New Design – 1Gb NOR used

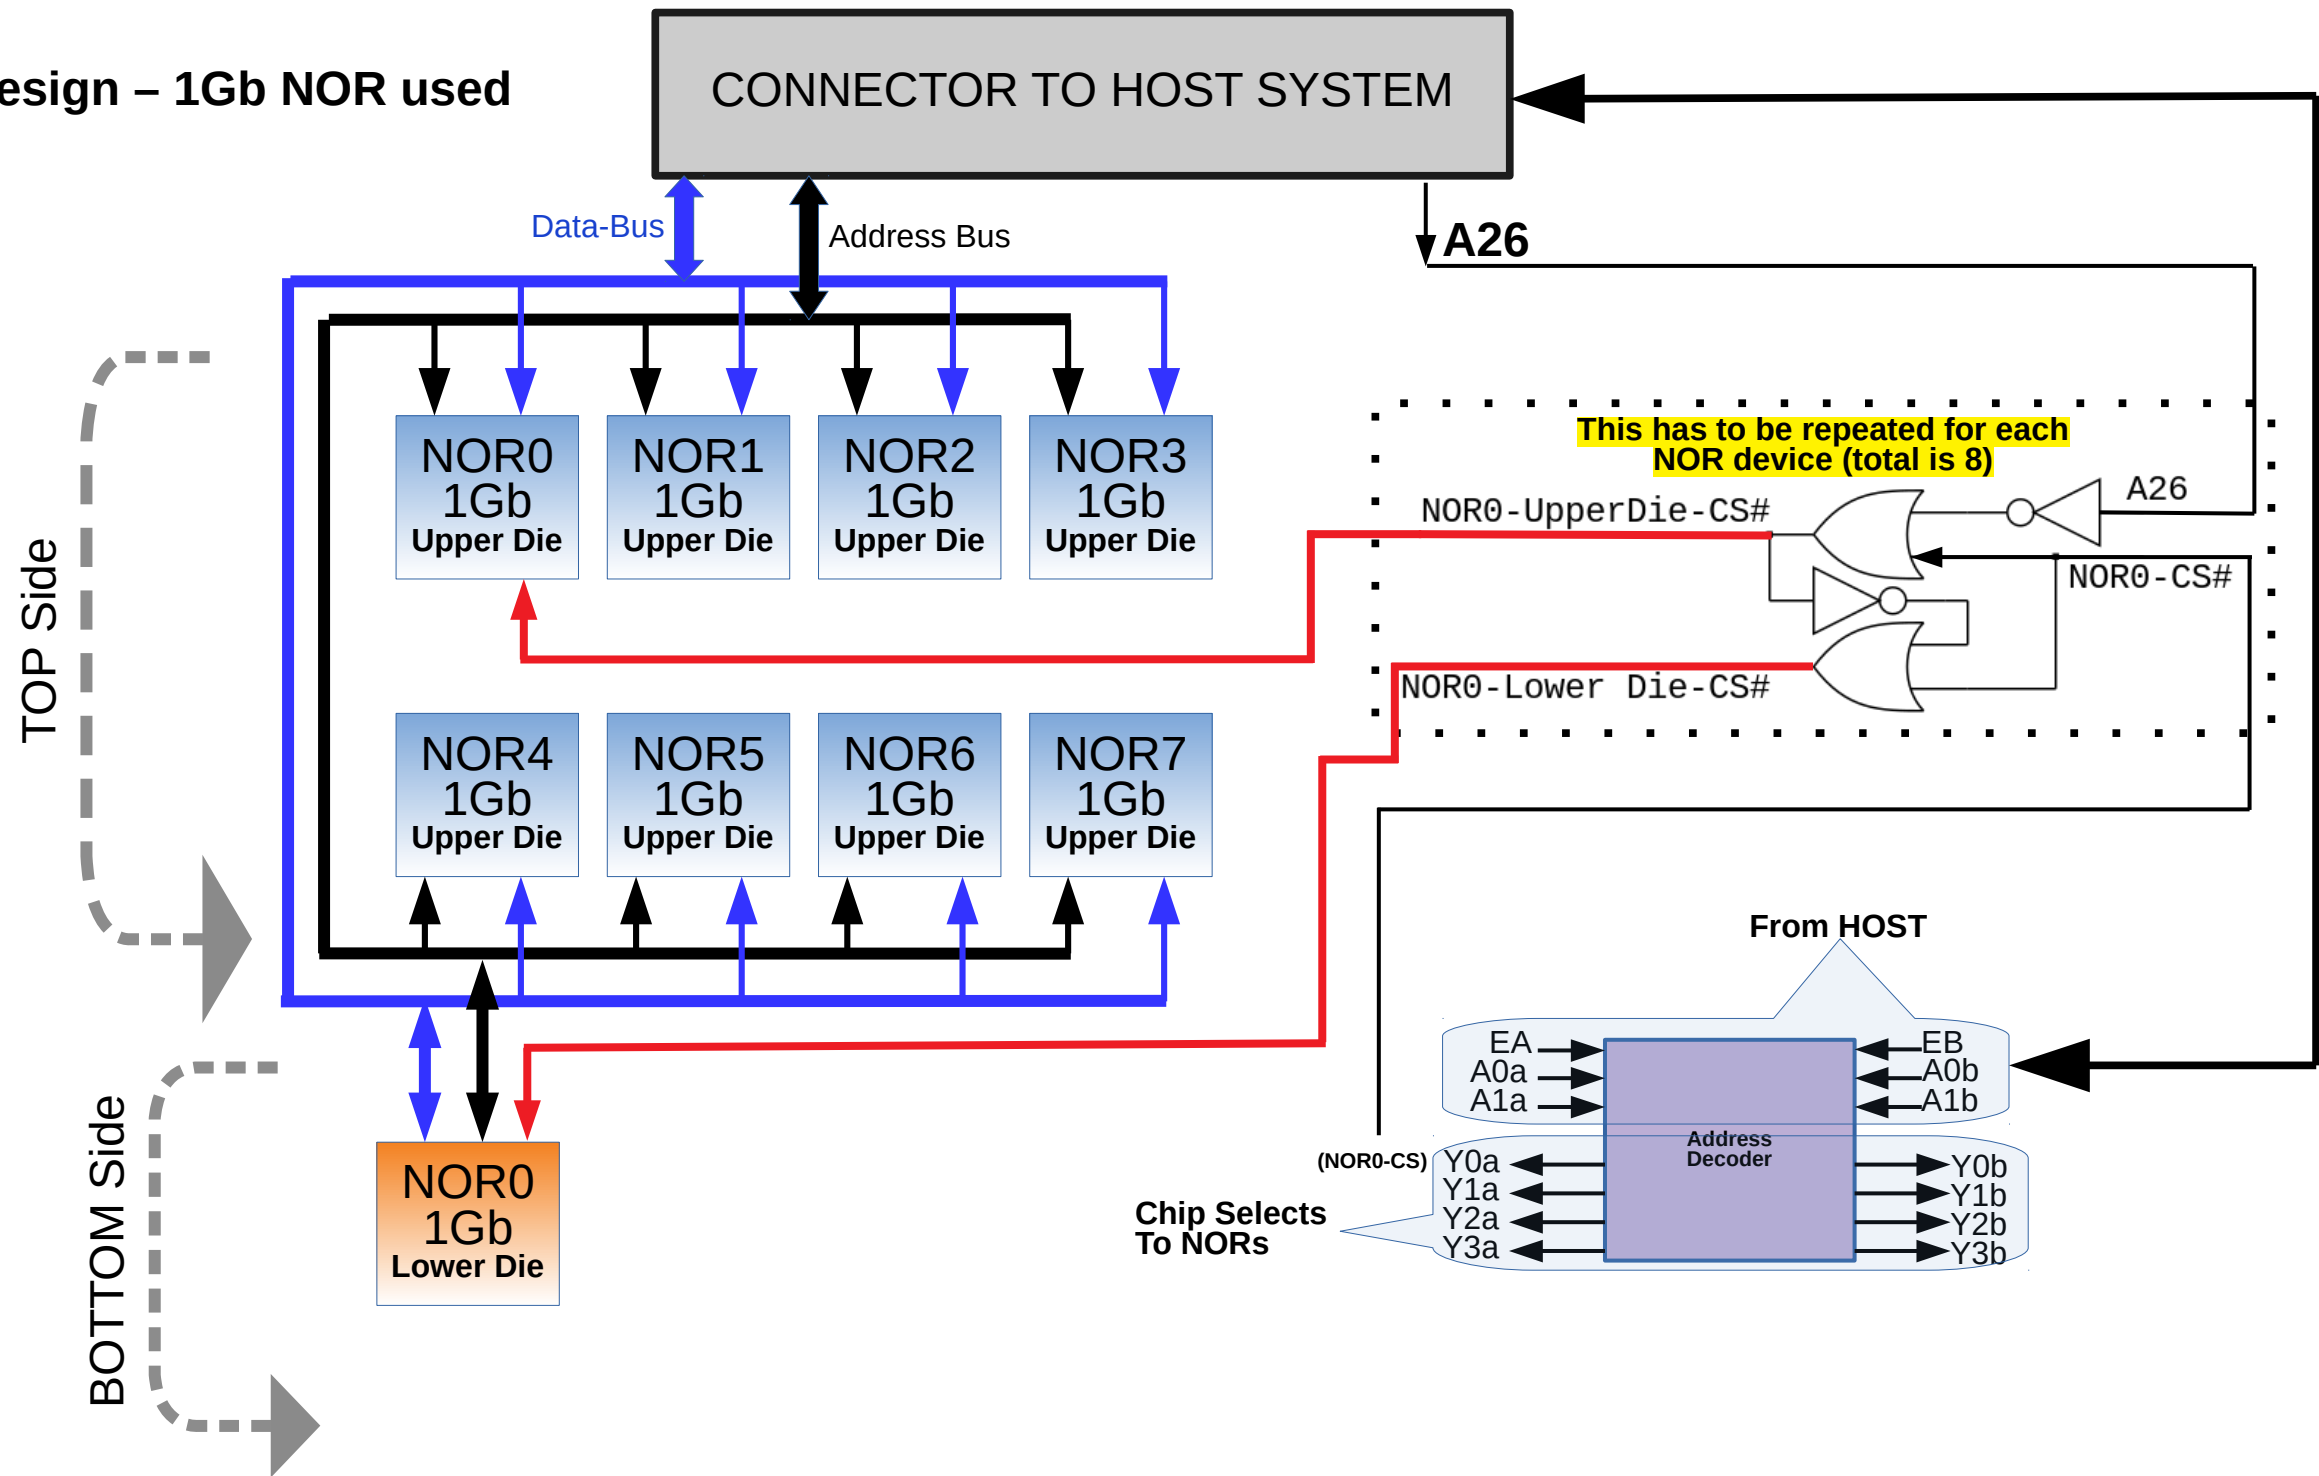
Only one device shown
There should be one
device acting as a lower
die for each NOR on top
side.
